Sheridan Street Project Portland, Maine Construction Management Plan

8. RESPONSE TO PEER REVIEW COMMENTS

Subject: Sheridan Street Apartments
Preliminary Site Plan Application
Response to Peer Review Comments

Roof Drain Filter Samples

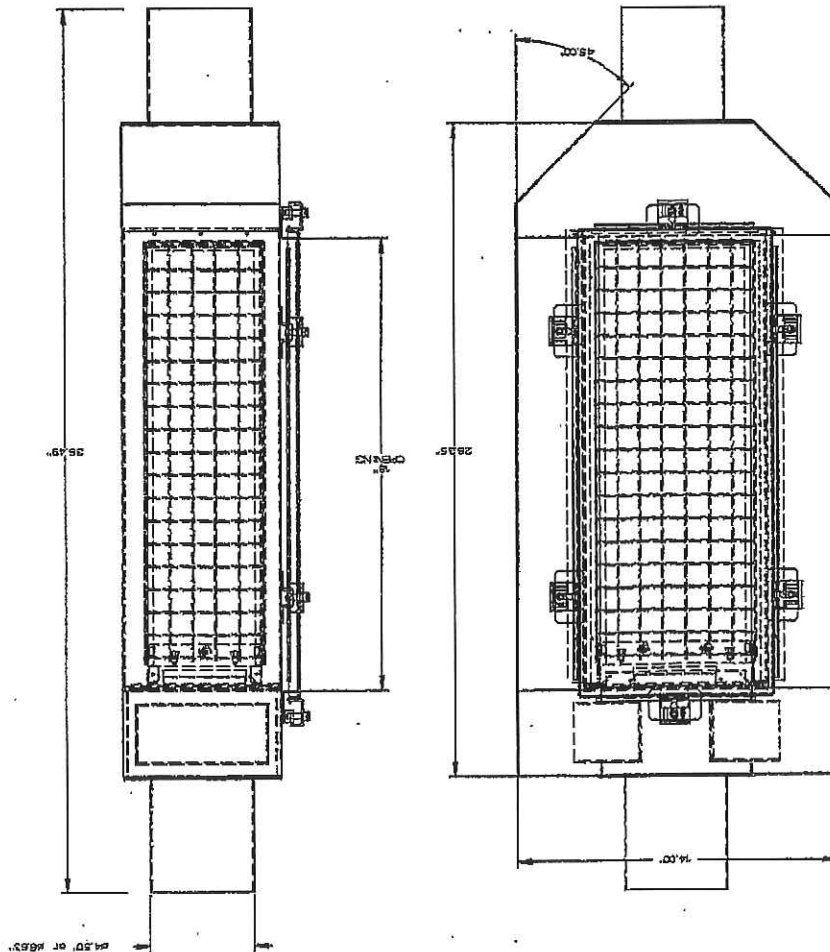
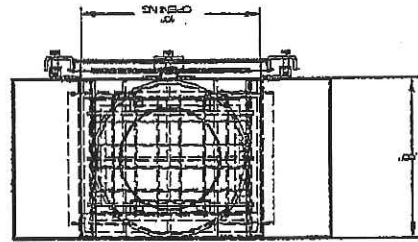
b. *General Standard: The proposed roof-area is considered new impervious area. Any clearing that occurs as part of the construction would be considered new developed area. As part of the final application, the applicant will be required to submit a stormwater management plan identifying a stormwater treatment method for the site. The stormwater treatment system shall be sized in accordance with the General Standards to manage runoff from the new impervious and developed areas of the site; or an equivalent, adjacent area. The infiltration practice proposed on the Preliminary Submittal may be acceptable, but engineering calculations showing conformance with the General Standards should be provided with future submittals.*

The Stormwater Management Plan should include a stormwater inspection and maintenance plan developed in accordance with and in reference to MaineDEP Chapter 500 guidelines and Chapter 32 of the City of Portland Code of Ordinance.

The applicant proposed to discharge roof runoff into the City's municipal drainage system in Sheridan Street. Based on the relatively minor flow emanating from the building roof, the City's system is expected to have adequate capacity. In order to provide water quality treatment, the project will include a roof drain filter system such as those described in Attachment A to this letter. The applicant requests the right to make a final selection of the roof filter system during construction.

The applicant proposes to complete routine maintenance of the roof drain filter and related drainage system. This will involve year round observations of these systems (similar to all utilities) and replacement of the filtering measures as recommended by the product manufacturers. Notes regarding these requirements have been added to the plans.
